**MEMORANDUM**

REVIEW TYPE: Site Plan

PROJECT NAME: Germantown Veterinary Clinic

CASE #: 8-02028

SITE PLAN

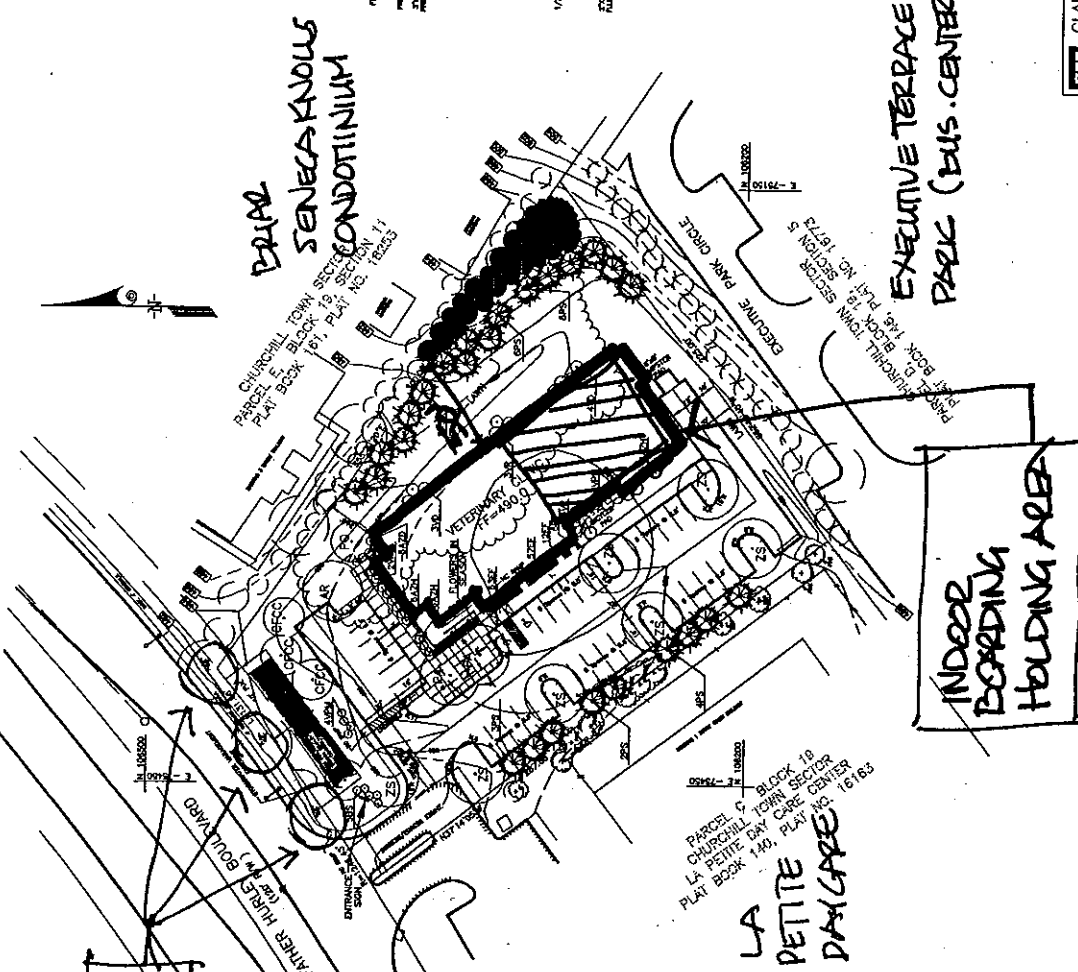
- c. Landscaping and Lighting
 - i. Submit tree protection plan showing tree save on site and mitigation/protection measures for trees on adjacent properties; provide tree protection plan and root zone analysis for the oak trees on Father Hurley Boulevard.

- ii. Provide screening hedge at least 3 feet in height along property frontage at PUE line;
 - iii. Provide additional screening of White Pines along the north property boundary; provide screening along south property boundary using Leyland Cypress; coniferous screening trees to be installed at 6-8 feet in height and 12 feet on center;

- iv. Provide additional Okame Cherry tree at front near lead sidewalk;
 - v. Provide specifications and locations for all fixtures, including fixture type, pole type, wattage, house shields, mounted height, and hours of operations.

- vi. Provide revised photometric lighting plan, using IESNA standards of 0.5 footcandles at all property lines; provide average max/min ratio of 5:1.

ARCHITECTURAL ELEVATIONS

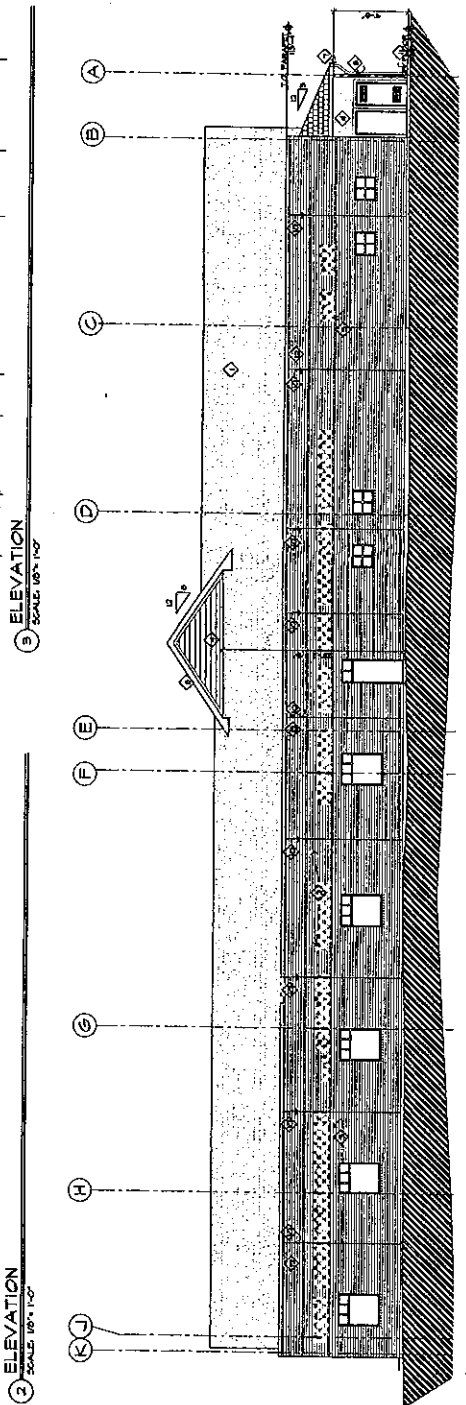
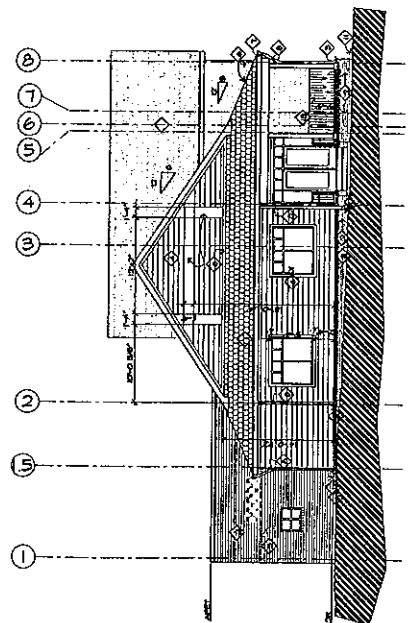
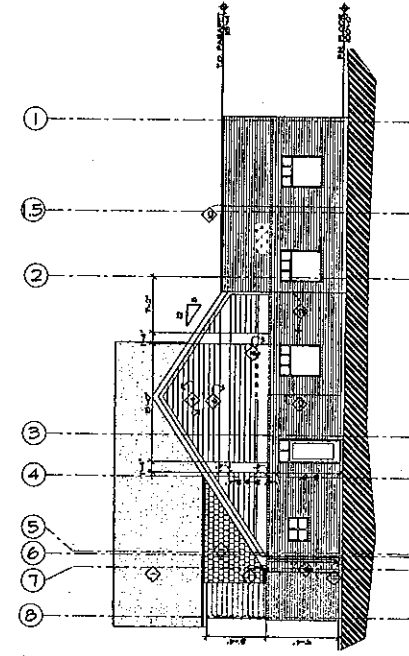
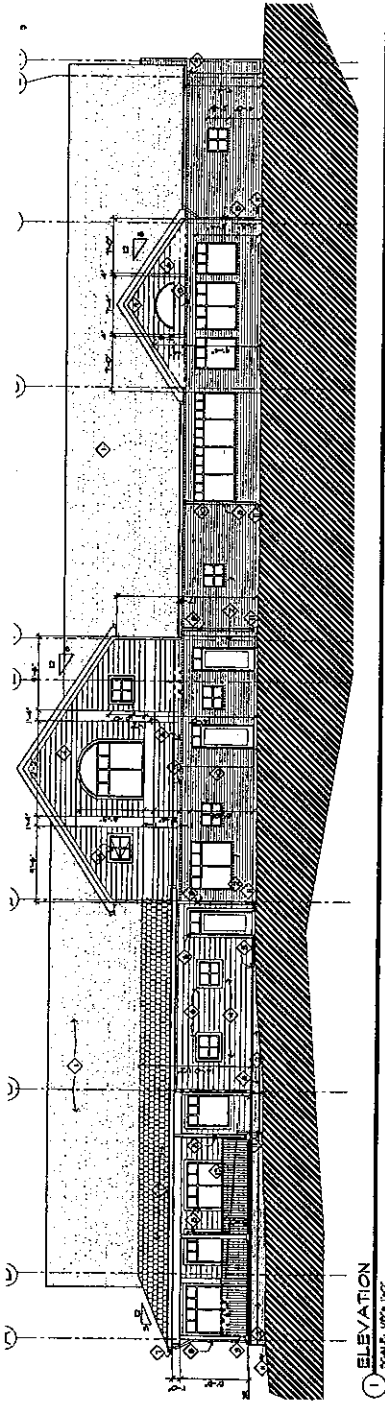
5. Limit hours of operation to the following:
Monday – Thursday 8:00 am - 8:00 pm; Friday 8:00 am - 6: 00 pm; and Saturday 8:00 am - 2:00 pm.
6. Provide for staff review and approval details and specifications for any façade design alterations (such as wall openings for windows and doors) affecting soundproofing and noise control.
